TI_2216: Information – iCombi Pro software version LM100-16.1.15

iCombi Pro, Index J

31/05/2022

Since 24/05/2022, all iCombi Pro, Index J, have been delivered with software LM100-16.1.15.

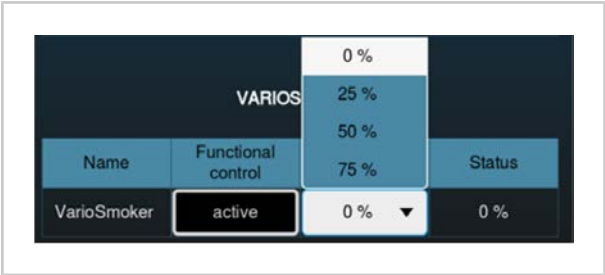
- The function tests have been changed and extended under Starter "**Service steam**" and Starter "**Service hot air**" > Function tests > Gas components and Information gas components:

- In addition to the steam heating system, the hot air system(s) can now also be tested.
- All gas burner systems (steam and hot air) are now activated with push buttons (max and min power separated) instead of a dropdown menu.
- The gas blower motors for testing without an ignition process are now actuated in the speed levels max and min instead of 25% increments in the same way as the flue gas analysis.

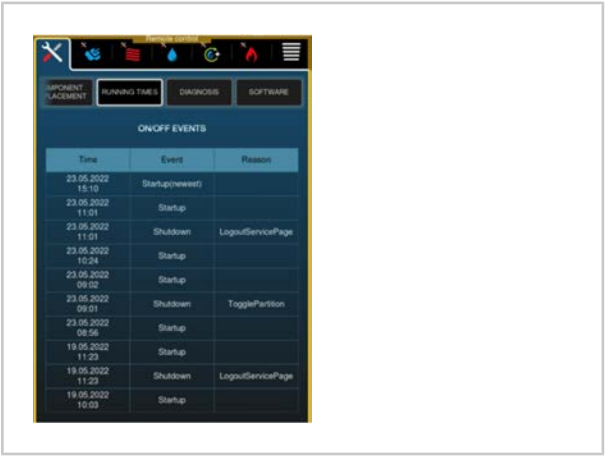
- A connected VarioSmoker can be tested under Service "General" > "Basic settings". To do this, the VarioSmoker must first be set to "On" under "Settings > Cooking system" and the unit restarted.

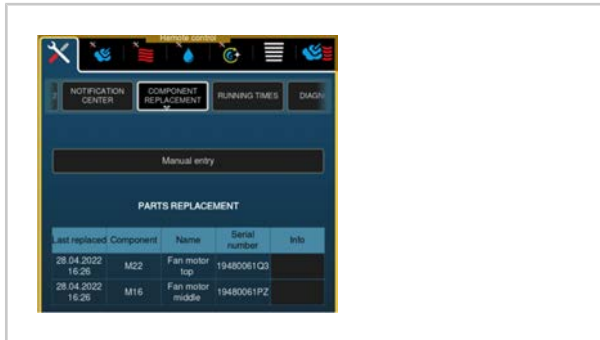
- The last ten on/off switching events of the unit are displayed with the time and reason for switching off.
Notice: "Startup > Startup > Startup" can appear directly one after the other, which does not seem logical at first glance, as switch-off processes appear to be missing. But the hard switch off processes (forced switch off, power failure) are not recognised and this can result in "Startup > Startup > Startup ...".

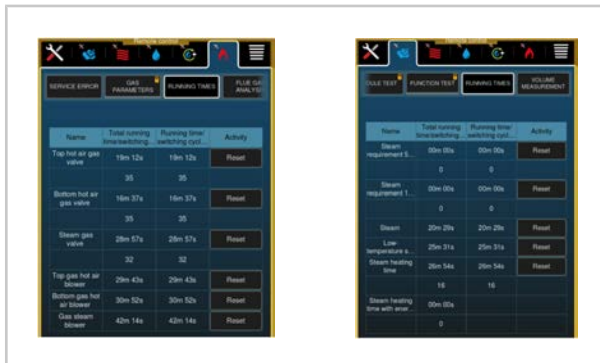
- Specification, expansion and simplification of the component replacement history for maintenance work documentation purposes via automatic recognition of bus components ("I" = initially installed component, "M" = replacement of a component with manual entry, "A" = automatically recognised component replacement).

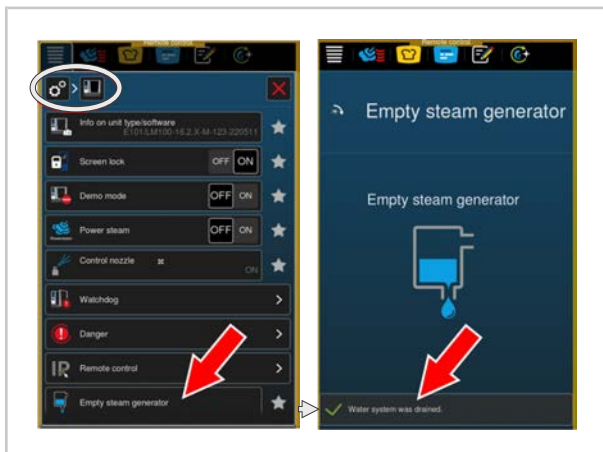
- In rare cases, the "**Moisten**" button could no longer be activated. This issue has been resolved.
- Subsequent adjustment of the time after the door was closed in the Finishing/Smoking cooking path was not possible. The time can now be set again at any time.
- The transparency of messages on the screen has been improved in order to make underlying setting options more recognisable for our customers. In particular, the prompt to close the door at the start of a cooking process concealed the available setting options for end options until now.
- A network diagnosis can be carried out under "**Settings > Network settings**" to check the network and ConnectedCooking availability.

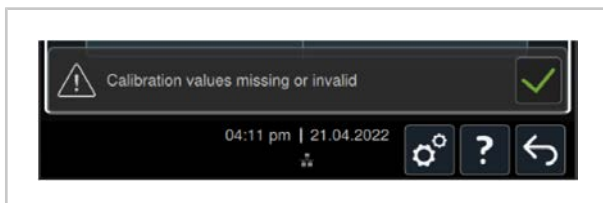
- With the new "**Empty steam generator**" function under "**Settings > Cooking system**", the steam generator, the cleaning box and the water paths of the iCombi Pro can be emptied. This can be used for transport requirements (e.g. catering business) or seasonal requirements (e.g. summer break in a ski lodge).

- The menu navigation or sequence for this is: Close water tap > operate hand shower > automatic emptying of steam generator > pump cleaning box empty.
- **Important:** The process is not used to redetermine the steam generator volume, as is the case with older unit lines!
- If a unit has no or invalid calibration values, a warning message appears. The user must confirm this; cooking can then take place, but uneven cooking results must be accepted.

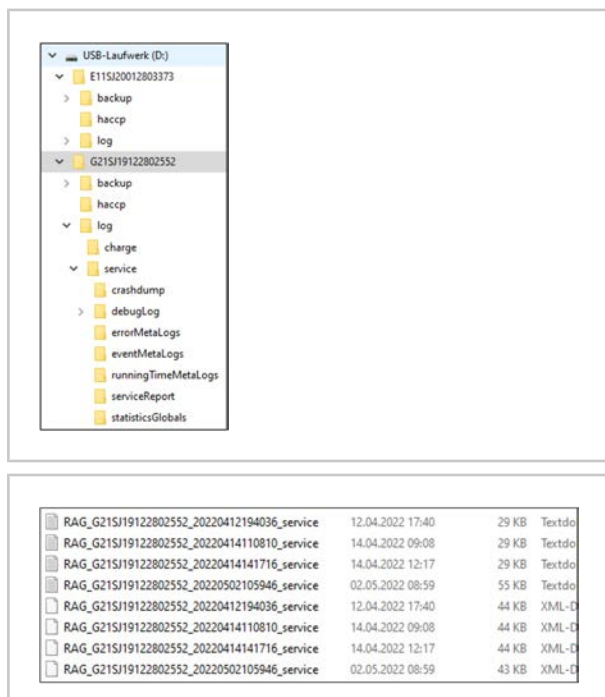
- Export data to a USB stick ("**Settings > Data management**")
 - When an export action is triggered, a check is carried out to determine whether there is enough free space on the USB stick and a warning message is issued if necessary.

- If this function is carried out, a directory name with the serial number of the unit will now be shown on the USB stick in the file structure. This directory contains all exported data in specific sub-directories. If further downloads are carried out at a later time, these will automatically be copied to the corresponding sub-directories already created. This chronological, serial number-based filing provides a better overview and a better possibility for comparison, as all files have been written to the root directory of the USB stick until now.
